PREVOST

**SAFETY
RECALL**

Sr05-06

DATE : May-2005	SECTION : 16
SUBJECT : IMPROPER MOUNTING OF 3 RADIUS ROD SUPPORTS

FIGURE 3: REAR SUSPENSION

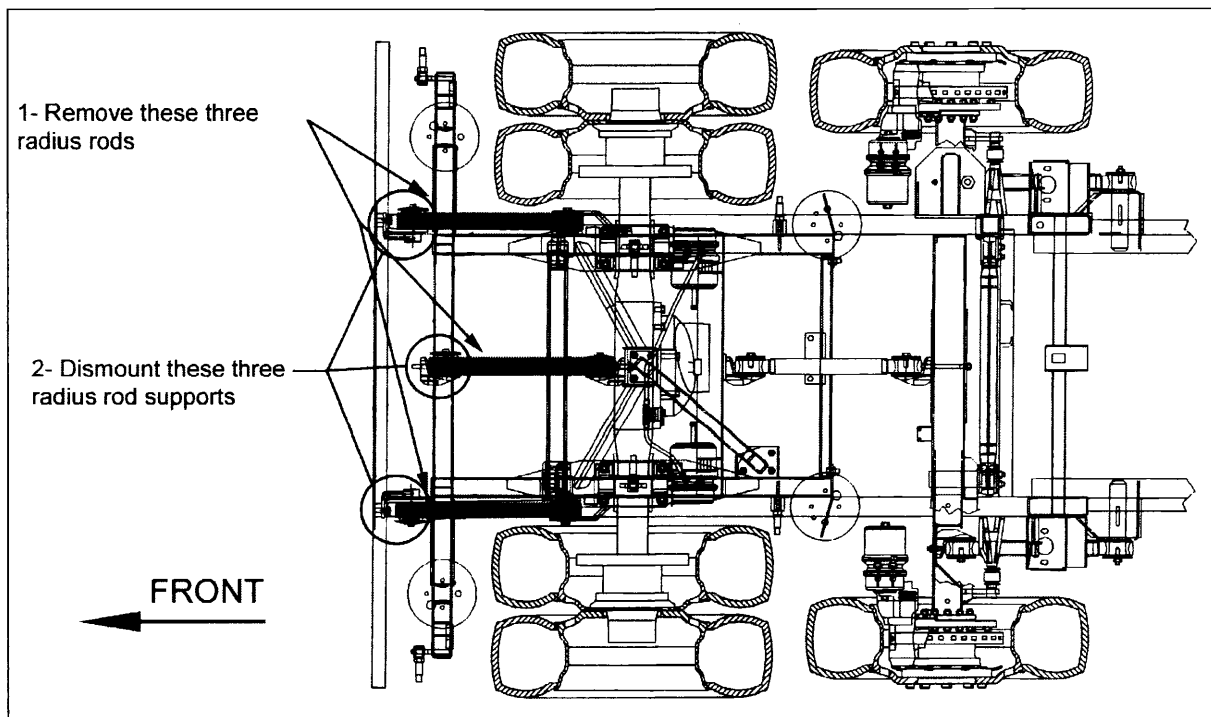
5. Dismount successively the 3 radius rods identified in figure 3 by flattening the tabs of locking plate and by unscrewing the two bolts directly fastened into radius rod pivot (if needed, refer to maintenance manual).

6. Dismount successively the 3 radius rod supports identified in figure 3. Take note of the position and quantity of shims in order to reinstall the components in the same condition as they were to maintain proper vehicle alignment.

FIGURE 4: SUPPORT CLEANING (typ. 3 supports)

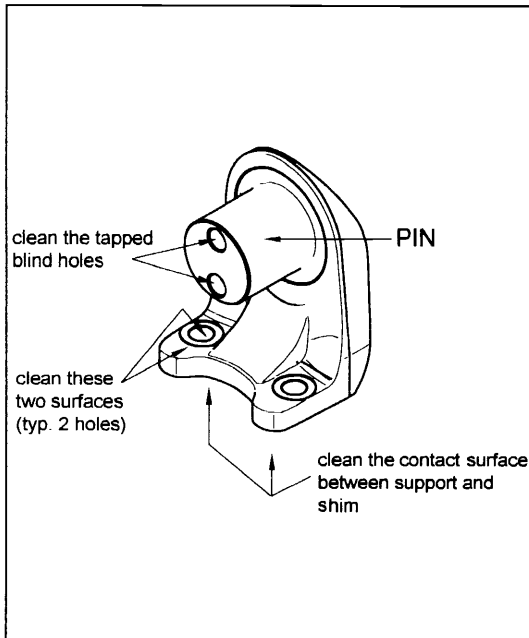
7. Using brake cleaner, thoroughly clean the 3 supports contact surfaces to remove all trace of anti-seize compound. Clean the contact surfaces between support, shim and structure. On supports (see figure 4), clean the contact surface of the bolt head, the passing holes and use brush #684901 to clean the tapped blind holes. Use brake cleaner and a clean clothe to dry.

FIGURE 5: CLEANING OF 2 PINS AND THE CENTRAL SUPPORT PIN

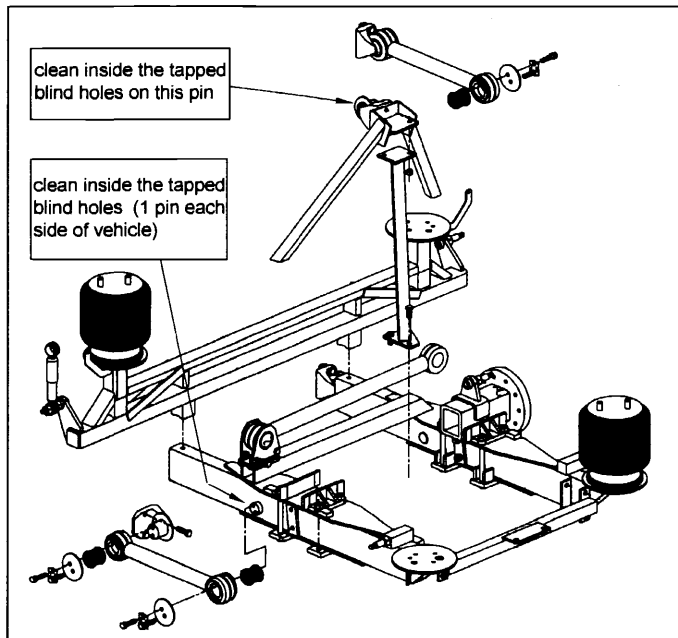
8. Clean inside the 6 tapped blind holes where the supports are bolted. Use brake cleaner, brush #684901 and a clean clothe to dry.
9. Clean inside the tapped blind holes of the 3 support pins identified in figure 5. Use brake cleaner, brush #684901 and a clean clothe to dry.

FIGURE 6: REAR SUSPENSION

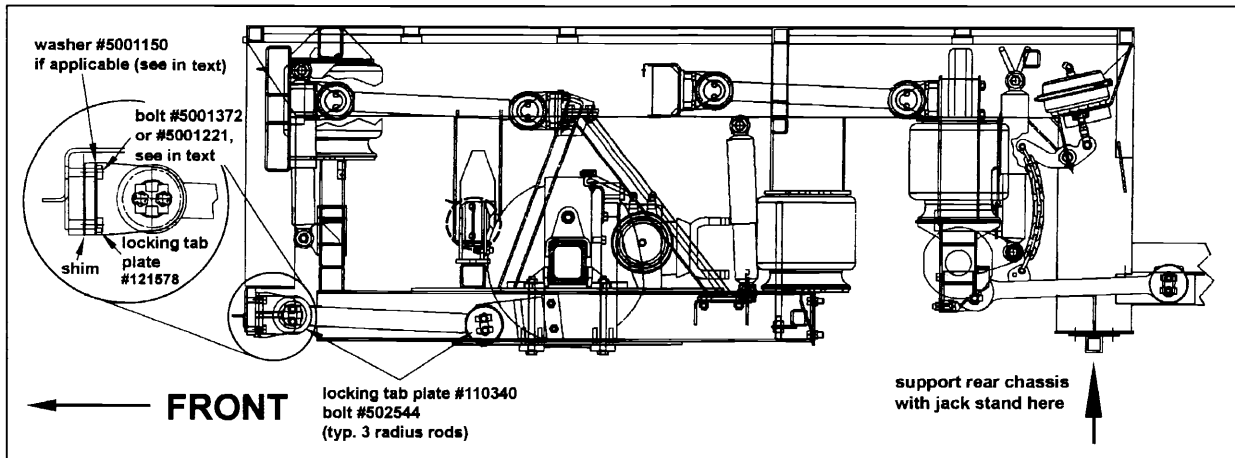
10. Reinstall the supports (figure 6). Do not forget to reinstall the shims correctly.

- Use 2 new bolts (#5001372) per support. If your vehicle is included in the range beginning from 2PCW3349451028407 up to 2PCW3349X51028461 inclusively, you must use bolts #5001224 instead.
- Use new tab locking plates (Prevost #121578).
- For the outer left and right supports, you must use new washer (#5001150) if the total thickness of their respective shims is less than 1/8" (3mm).
- Put 3 drops of Loctite 243 (Prevost #680038) in each of the 6 tapped blind holes and a line of Loctite on bolts.
- Tighten bolts to a torque of **185-205 lbf-ft**.
